Our Case Number: ABP-314597-22

Re: BusConnects Galway Cross-City Link Scheme.
University Road to Dublin Road, Galway City.

GCCN Submission

Re: An Bord Pleanála 314597: University Road to Dublin Road, Galway City.

Figure 4.74: Example of an drainage channel on Exhibition Road, London. The kerb line indicates an area of pedestrian refuge and is used to guide the visually impaired.

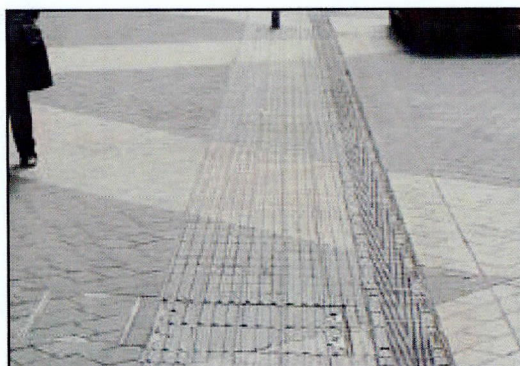
Drainage treatment should be under the footpath. **A surface channel with a dished effect should not be permitted in public areas where pedestrian and cyclists are crossing.** A flush drainage channel should be used and grill to allow for drainage of surface water to rapidly clear away from the pedestrian/cycle facility.

Request that drainage channels on footpaths and at intersections where cyclists transition over are recessed Aco style drains. The use of surface concrete dished water channels is problematic for maintenance and presents a hazard of slip/trip for pedestrians and cyclists. They present additional issues for wheelchair, buggy and mobility impaired users as there is an unexpected change in level.

Additional issues relating to gradients for drainage and cleaning surface channels are eliminated with the use of recessed drains as shown below.

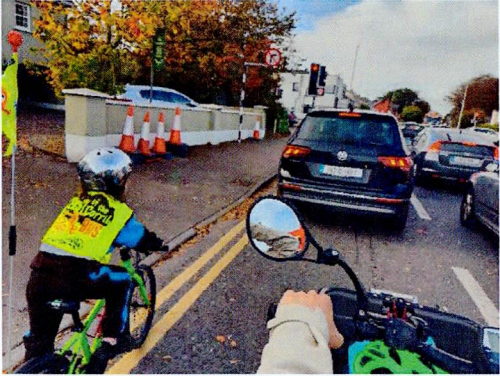
Where the footpath has been built out to reduce overall road width or calm traffic there will be a new risk to cyclists of all ages as busses, lorries and cars will likely overtake many cyclists in the city shared street. During the delivery hours of 10am-1pm there is a considerable increase in the risk to cyclists with delivery lorries operating in the 3 hours window and as they begin to enter and exit the restriction zones at the start and end.

There will inevitably be traffic queuing and cyclists will be forced to wait in line, both inside and outside the scheme. This issue needs to be addressed and mitigated at junctions and approach to junctions. This will most likely result in cyclists opting for their perceived safer and quicker option of cycling on footpaths to reach the top of a junction and cross it potentially. All these movements are unsafe and undesirable for everyone.

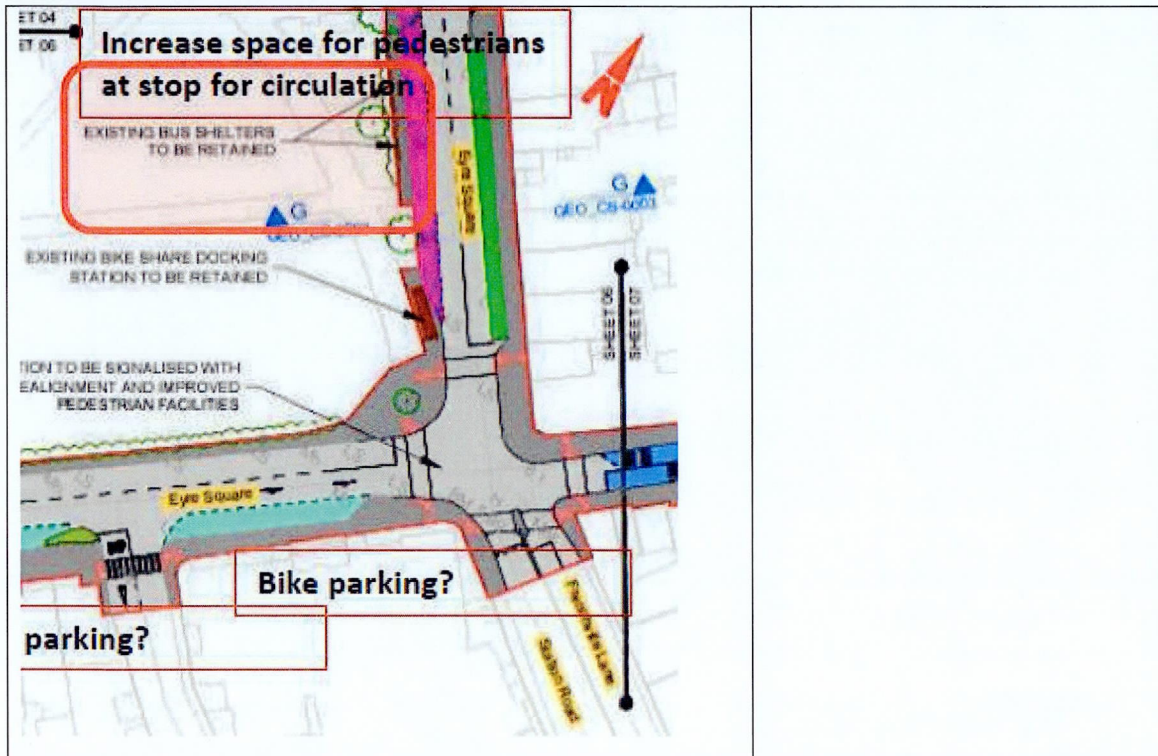
<p>access for cyclists and turning right</p> <p>Increase space for pedestrians at stop for circulation</p>	<p>The safety review for the Cross City link requested that bus stops be set back further from the kerb and greater circulation space be given at some bus stops in Eyre Square. It also noted that there were discontinuous/lack of clear access routes approaching the bus stops due to upstands for example of trees.</p> <p>The space at the bus stops and access to the stops proposed at the Northeast side of Eyre Square needs review as greater number will use the bus. More space is needed for safety and to make the space inviting</p>
---	--

Bus waiting areas are still too narrow at Eye Square for circulation of pedestrians. This was highlighted in the Road Safety Audit with particular reference to the area opposite St Patricks Ave. More footpath width and waiting areas are required. If passenger numbers are to increase, then this is critical for overall safety and reaching design standards. Little effort is made to overcome pinch points at areas where trees and raised planting/landscaping are restricting the flow of pedestrians along desire lines. See southeast end of Eye Square.

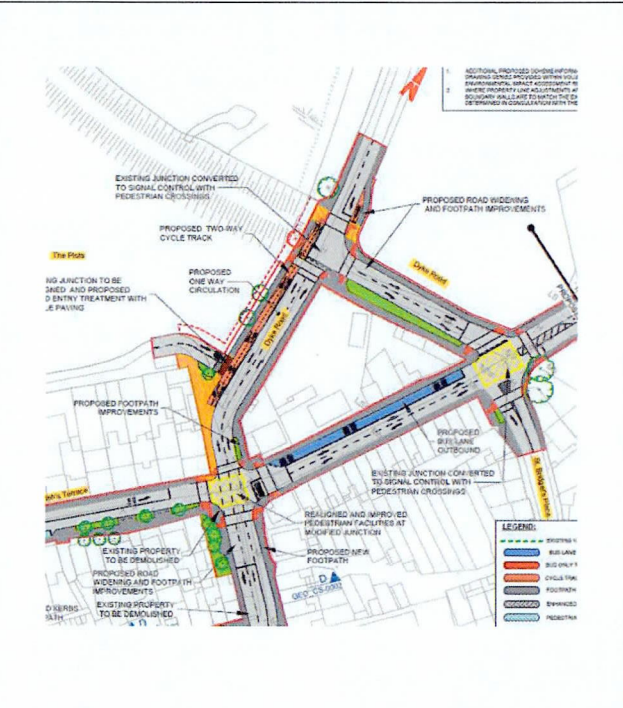
Cyclists lack facilities on Inner City Access on one way multi lane roads, access from **Dyke Rd to Plots cycle track** design tight and low priority access. Lanes narrow – no space for filtering. Should have segregation for cyclists and advance start waiting areas for cyclists.

Desire lines from **College Road** to off road short cut behind **Huntsman** to access the Old Dublin Road is poor and lacks intuition. Cyclists would like to avoid the right turn at Wellpark earlier if possible. Access to dropped kerbs limited for cyclists who want to use permeability routes coming from Lough Atalia/College Road.

Little consideration and priority for cyclist accessing the city from the Dyke Road. Not all cyclists will use the Plots route.

Woodquay:

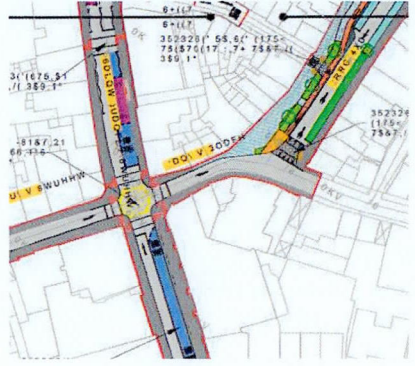
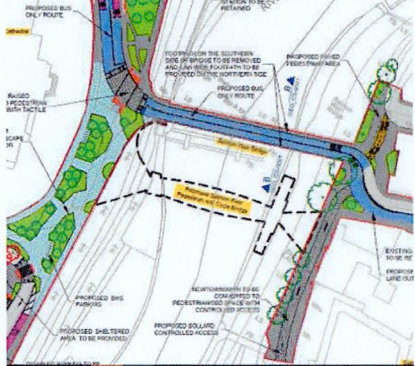
Cyclists exit from cycleway to cross Headford road and turn right or left should be improved. **Suggest** allowing for cycle lane to come to the head for Woodquay side road. Doing this will allow for confident cyclists to avoid having to cycle on a shared footpath space at a junction where there are two areas at the corner where pedestrians will be waiting to cross. It is **unnecessary to force all cyclist onto the path** as the road into woodquay side road is one-way (inbound) for traffic.

There is space to bring the cycle track on the side road to meet the main Headford road.

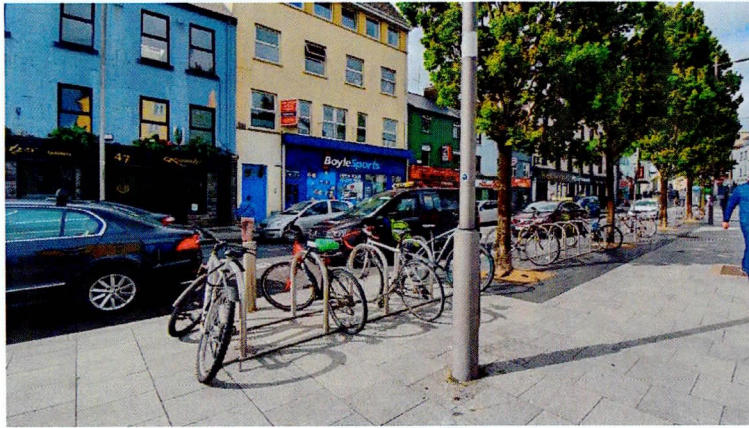
Poor location of cycle parking shown below due to antisocial behaviour and lack of social passive surveillance. This is located at the North end of Eyre Square Park, see below. There is little through put of people walking in this area despite it being in full display of the public.

Bike parking at the top of Eyre Square adjacent to Eyre St seems to be removed as it is not shown in the plans, see below. This bike parking is well used and well located. This bike parking should be retained and more added in connected locations close to the pedestrian core.

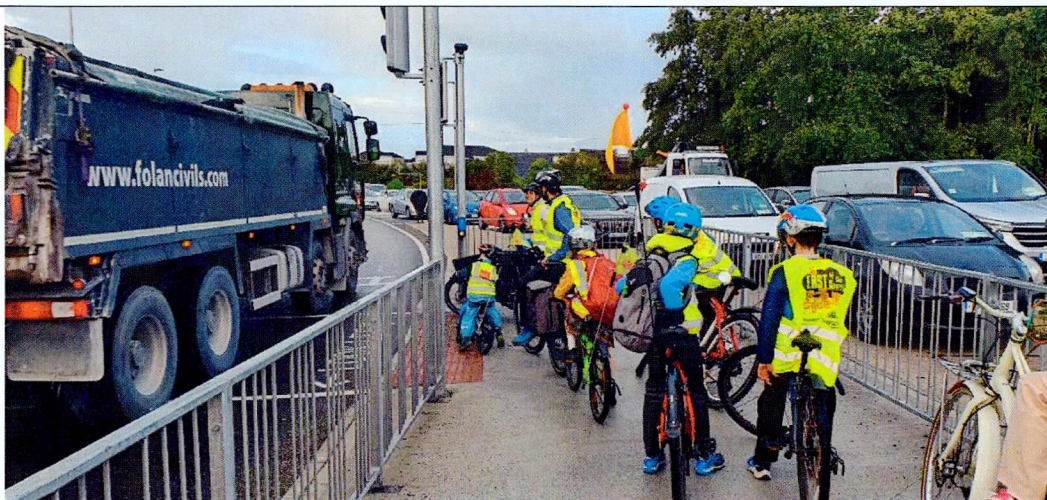
Cargo bike users are set back further from front wheel and so cannot safely reach toucan buttons. Manoeuvring is also difficult with load and angles to get to the button.

A child may way set back from the kerb and not be in the radar zone. Consideration to pick up more users waiting away from the kerb should be made

Design aspect to consider for toucan buttons: (not limited to this list) position of toucan button, space for passing, consider mixed pedestrians and cyclists, infra-red zone, **new cyclists flat toucan button at Kirwan is poor compared to standard larger pedestrian one**. Audible and tactile feedback is almost non-existent over the humdrum of motor traffic. Requests to increase audio and tactile feedback seem to be ignored. One engineer maintains nearby toucan crossing buttons noted that they have not seen these flat cyclist toucans before and there is no capacity to increase the audio in them. There is little space for error, need for high attention with traffic so close at these crossing points.
